# Design Modification Documents

<b>Client Name</b>	AGNICO EAGLE MINES
<b>Project Name</b>	AMARUQ PHASE 2 – IVR D1 DIKE

<b>Contract No.</b>	6127-E-132-003
<b>Contract Name</b>	IVR D1 DIKE CONSTRUCTION
<b>Site Engineering Query Register No.</b>	RFI-01
<b>Topic</b>	ESKER MATERIAL REPLACEMENT

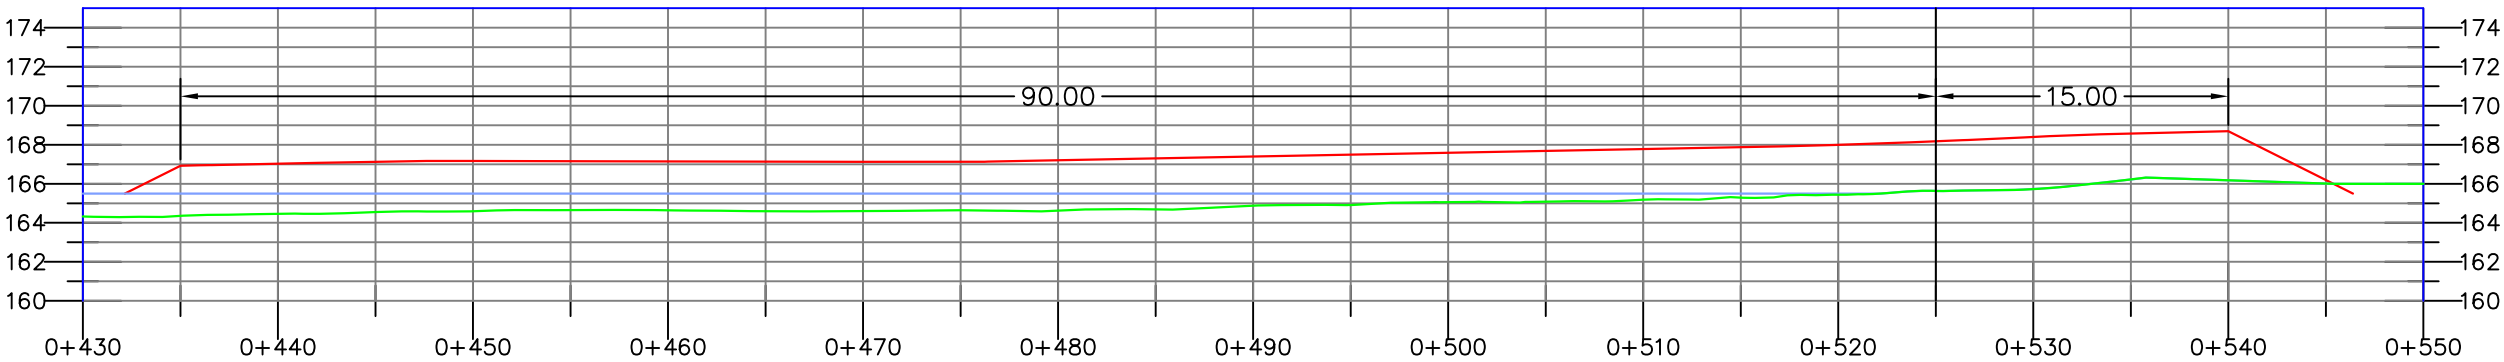
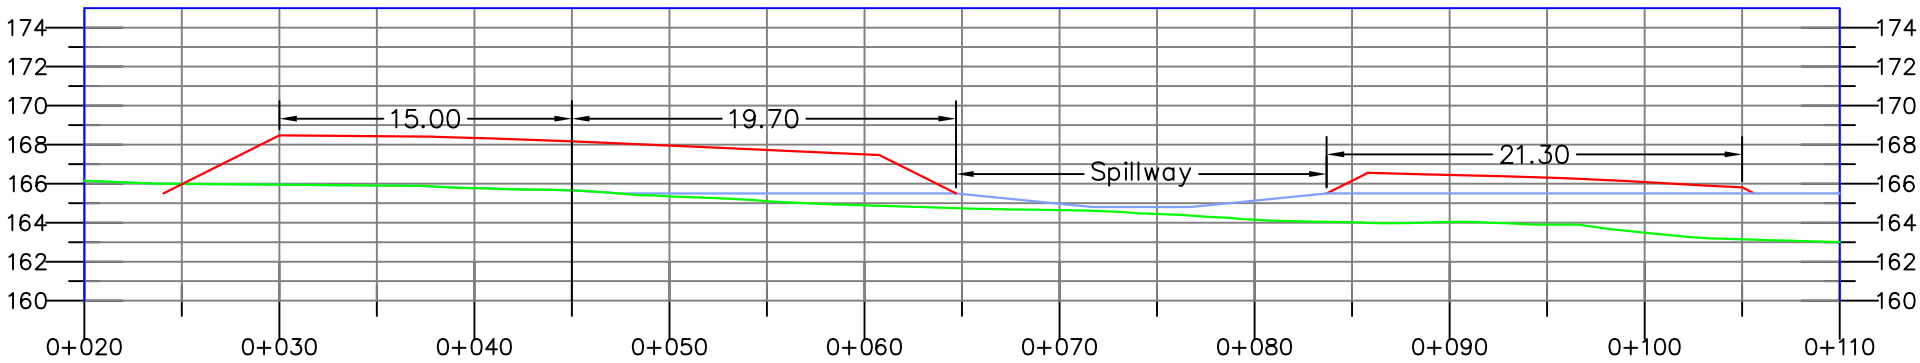
As placement of FFAB progressed per RFI-05, the conditions at the key trench bottom (overbreak in bedrock), along with losses at the mixing station and upon placement, were such that more bentonite was required to finish the dike construction than the remaining inventory available on site. Therefore, more bentonite had to be ordered from another mine site to finalize the construction. More optimization was also required with the new bentonite inventory on site. The following table presents the four scenarios evaluated.

Scenario #3 was the preferred option as discussed and agreed between AEM site representatives, AEM Engineer of Record and QA representatives. Therefore, a 0.3 m thick layer of FFAB with a 6% mix ratio was used to cover the LLDPE at the hinge section in the area comprised within the Maximum Operating Level (MOL). Following snow removal at hinge location after a blizzard, more FFAB was removed and replaced in the MOL area, affecting the quantities of remaining bentonite. Therefore, to cope with the remaining quantity available, the thickness of the lift that was used to cover the liner outside the MOL needed to be readjusted to 0.25m with a mix ratio kept at 4%.
